**REFERRAL OF DEVELOPMENT APPLICATION P16-215
TO WORKS & INFRASTRUCTURE DEPARTMENT**

Property No: 113000.03
Date: 17-Oct-2016
Applicant: Pitt & Sherry (obo JBS Australia)
Proposal: Installation of covered anaerobic lagoon - part of existing resource processing facility (ancillary to level 2 activity under EMPCA) (Environmental Impacts and Attenuation Code; Flood Prone Areas Code)
Location: 22 Tannery Road, Longford

**COVERED ANAEROBIC LAGOON (CAL) - JBS AUSTRALIA PTY LTD, LONGFORD
(PERMIT APPLICATION P16-215)**

Planning Application P16-215 – Response to third party assessment

Figure 2 - Proposed new wastewater treatment process

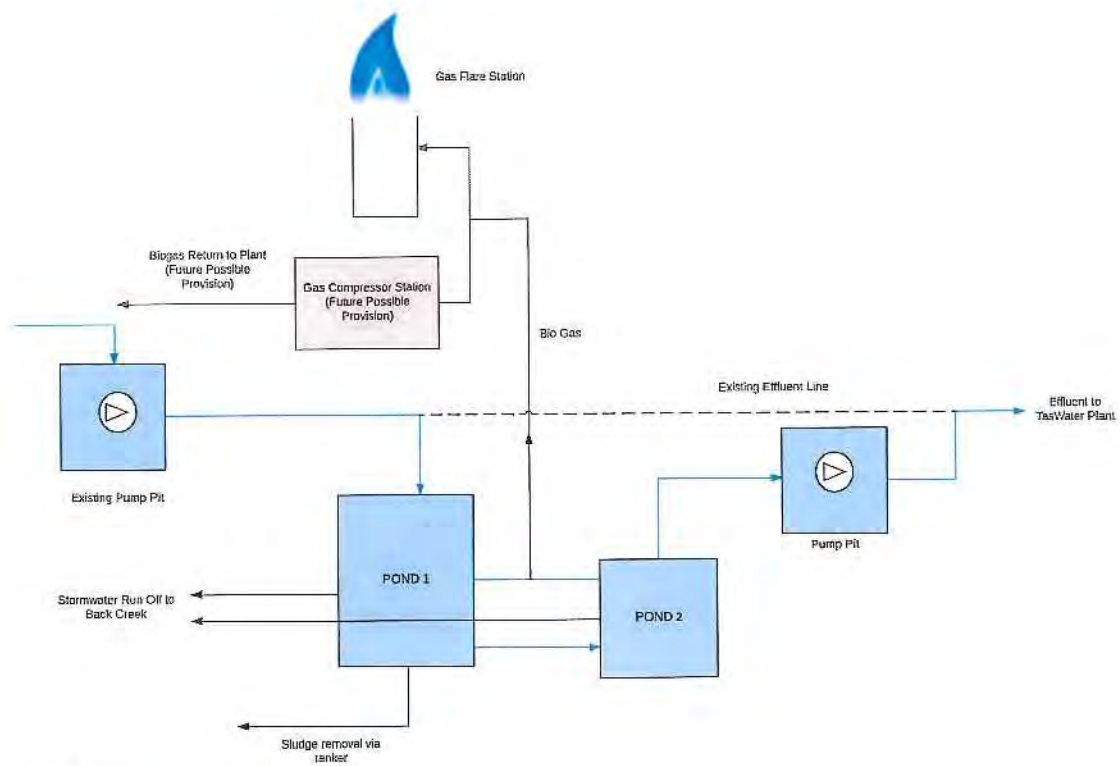
Stormwater run-off will be directed to Back Creek via open vee drains which discharge into the natural water course on the adjacent low lying paddock, refer to Figure 2, page 10 and section 6.2.4.

CAL design drawings

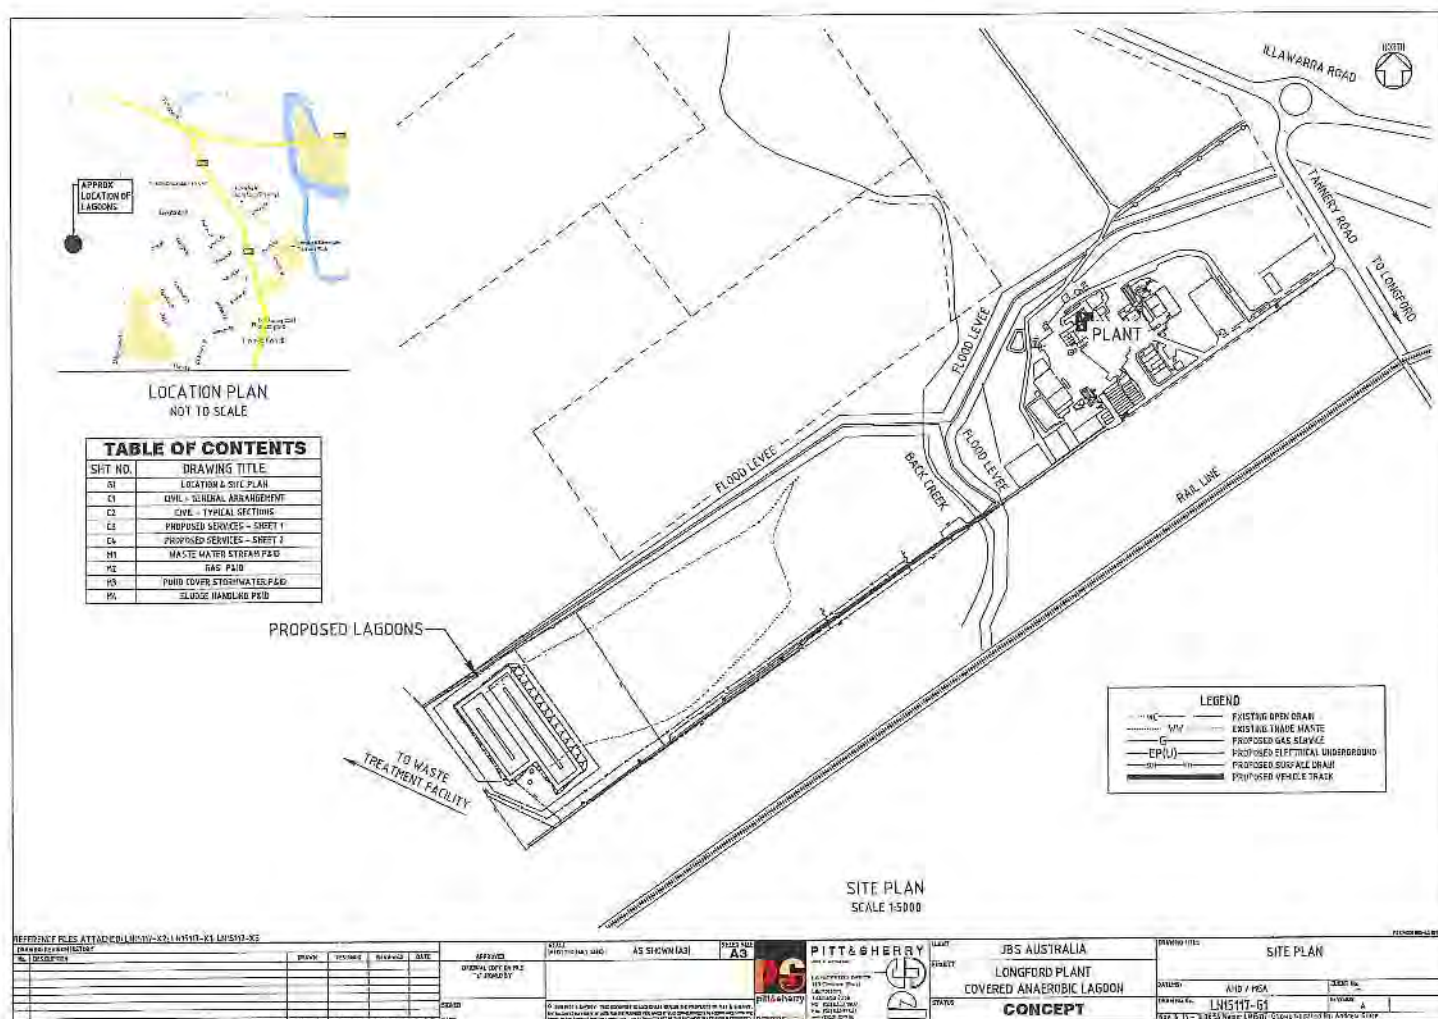
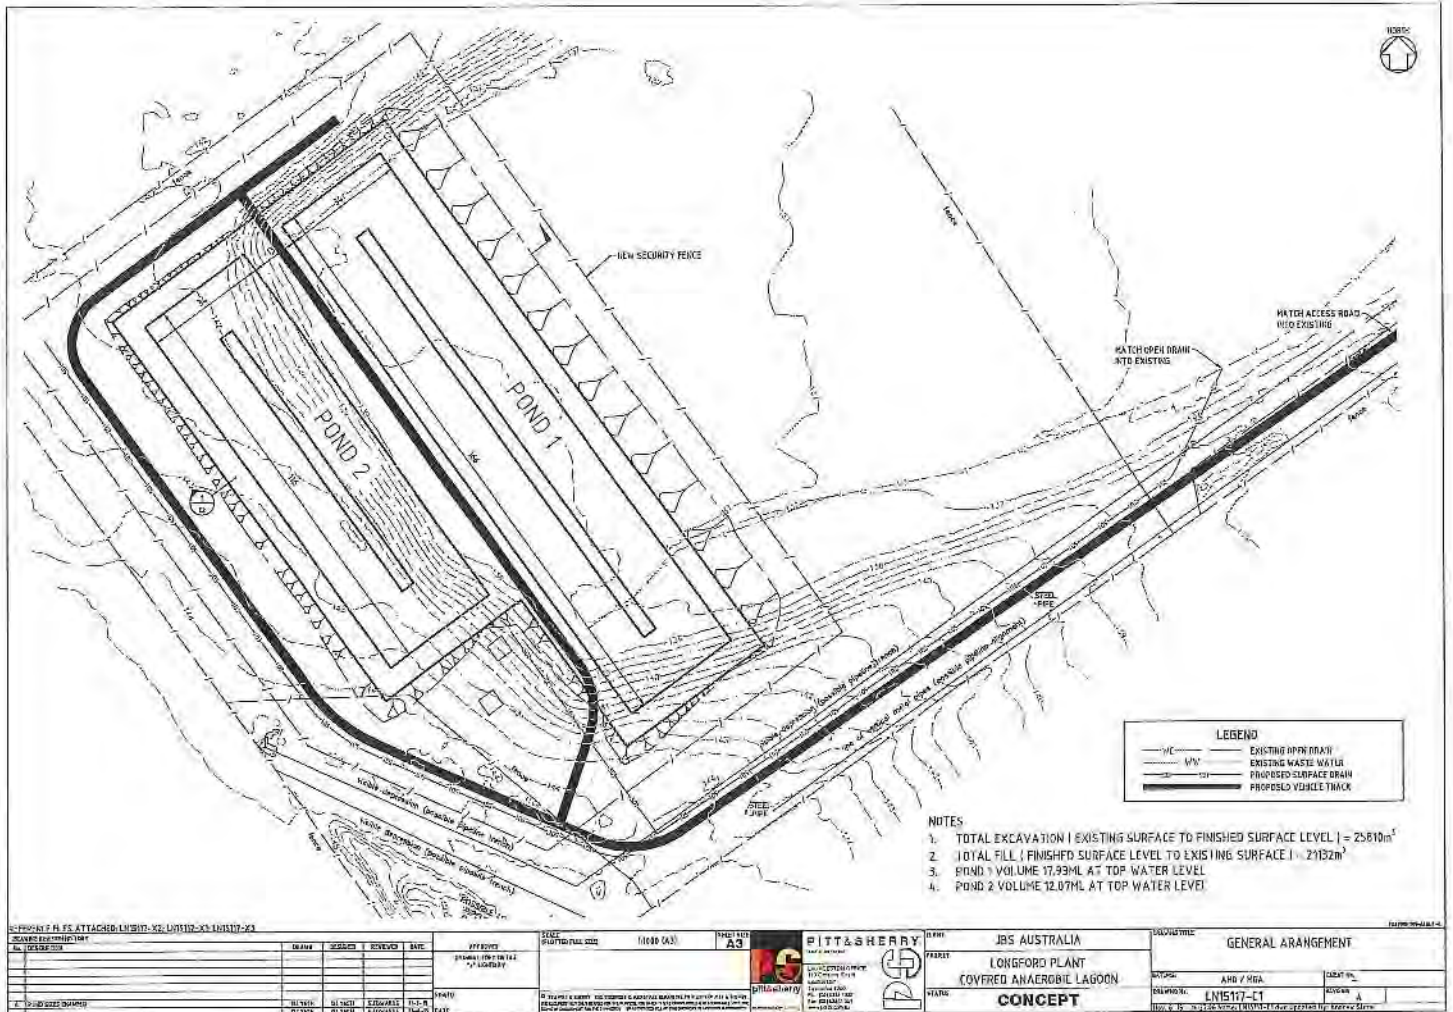
Noted that the proposed wall height around the CAL is 141.2. The 100 year climate change level with Back Creek gates open is 140.56
